**Proposed Development at Frogston Road East  
Response to City of Edinburgh Council memo of 11<sup>th</sup> December 2014 (Ref; 14/04860/FUL)**

This letter is in response to City of Edinburgh Council's (CEC) memo of 11<sup>th</sup> December 2014 regarding the flood risk assessment for the Frogston Road East site in Edinburgh (Ref; 14/04860/FUL).

**Figure 1: 200 year floodplain with 50% bridge blockage**

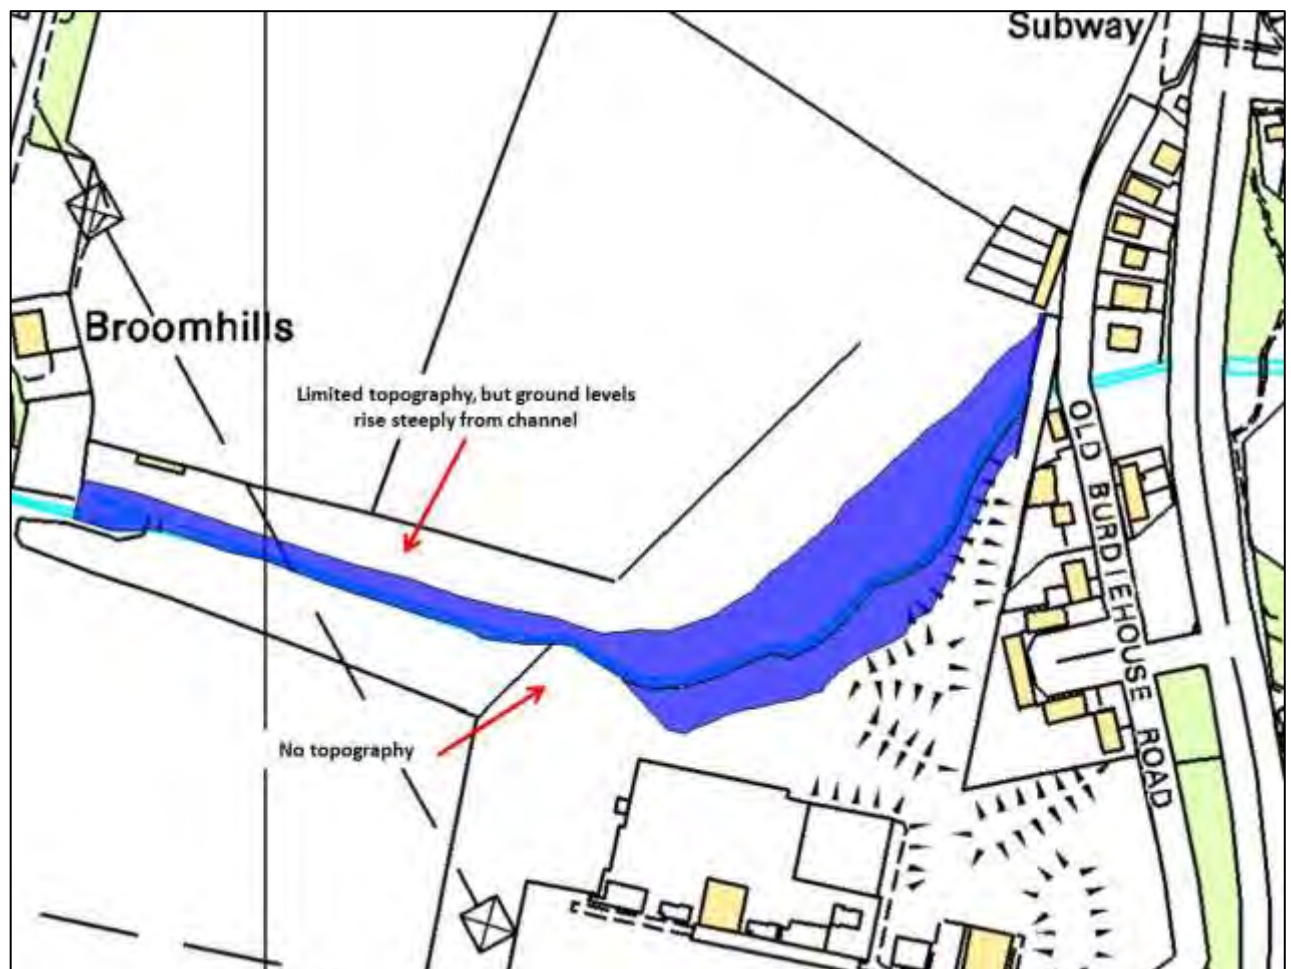
### ***Point 5.3. Model Sensitivity Analysis***

A flood map for the 50% blockage scenario is shown in Figure 1. This is consistent with the scenario considered in the Kaya flood risk assessment report sensitivity analysis. We note the CEC memo suggested a 60% blockage, but we assume this should have noted 50%, consistent with the blockage used in the Kaya sensitivity analysis. A run was undertaken with 60% blockage and it resulted in a minor increase in flood levels (around 0.06 m), which would produce a minor change in the flood extent (not visible on scale of Figure 1). This minor increase is because flood waters are already overtopping the bridge decks for 50% blockage.

Figure 2: A701 bridge crossing details

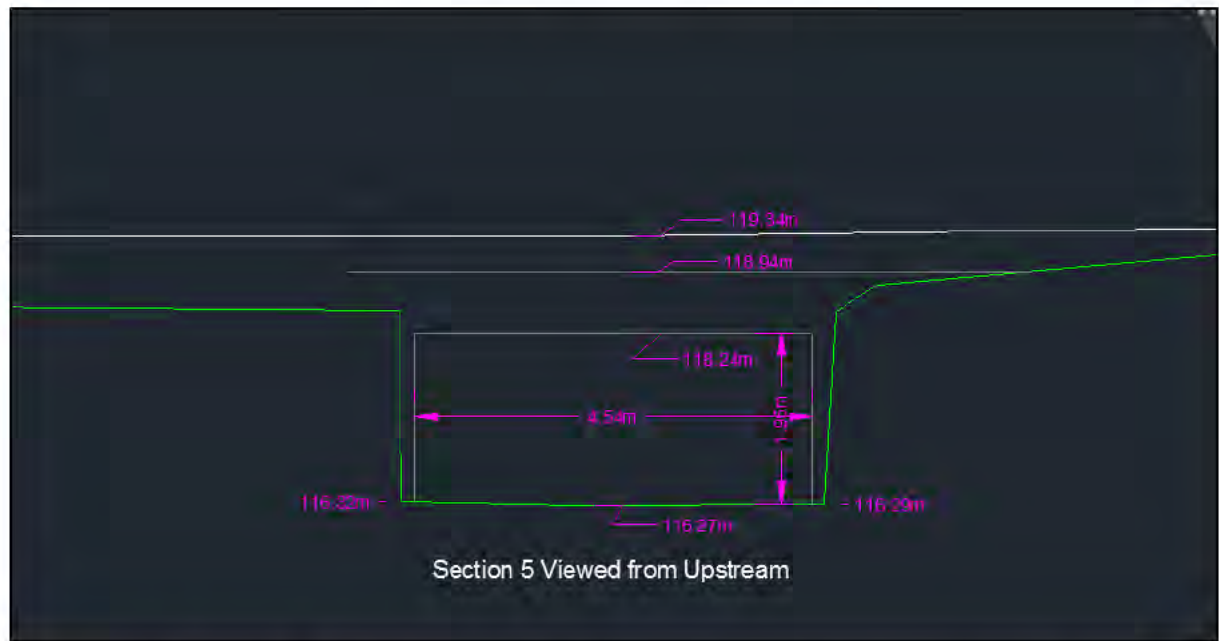
CEC noted that the downstream flood levels on the A701 road crossing (downstream of site) were higher than the bridge deck, while upstream levels were lower than the deck. The representation of the bridge in the model was reviewed and the following changes made;

- The bridge was originally represented as a 'Deck/Roadway' opening in HEC-RAS. Using this modelling method the model predicted an increase in the critical flow depth at the downstream end of the opening, raising the water level at the downstream bridge face. Based on the surveyed bridge opening, see Figure 2, the model representation was changed to a box culvert, which was felt to be more appropriate given that the bridge is a modern road crossing.
- The downstream road deck level was set too low in the original model. Based on the survey data the deck was raised by around 0.4 m. The original model used had taken a level on the downstream face of the bridge, while a review of the survey data of the roadway showed higher levels on the road.
